CPSES-200302754
Log # TXX-03137
File # 00236

December 31, 2003

SUBJECT: COMANCHE PEAK STEAM ELECTRIC STATION (CPSES)
DOCKET NOS. 50-445 AND 50-446
LICENSE AMENDMENT REQUEST (LAR) 03-07
REVISION TO TECHNICAL SPECIFICATION (TS) 3.8.1 AND 3.8.9,
EXTENSION OF ALLOWABLE COMPLETION TIMES FOR
DIESEL GENERATORS, QUALIFIED OFFSITE CIRCUITS, AND
AC ELECTRICAL POWER DISTRIBUTION SUBSYSTEM

ACTIONS

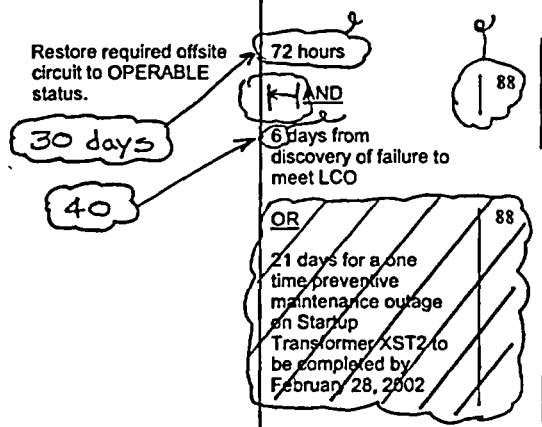
TS 3.8.1, "AC Sources – Operating," Actions, Page 3.8-2, Action A.3, Completion Time: change "72 hours AND 6 days from discovery of failure to meet LCO OR 21 days for a one time preventive maintenance outage on Startup Transformer XST2 to be completed by February 28, 2002" to "30 days AND 40 days from discovery of failure to meet LCO"

TS 3.8.1, "AC Sources – Operating," Actions, Page 3.8-4, Action B.4, Completion Time: change "72 hours AND 6 days from discover of failure to meet LCO" to "10 days AND 40 days from discovery of failure to meet LCO"
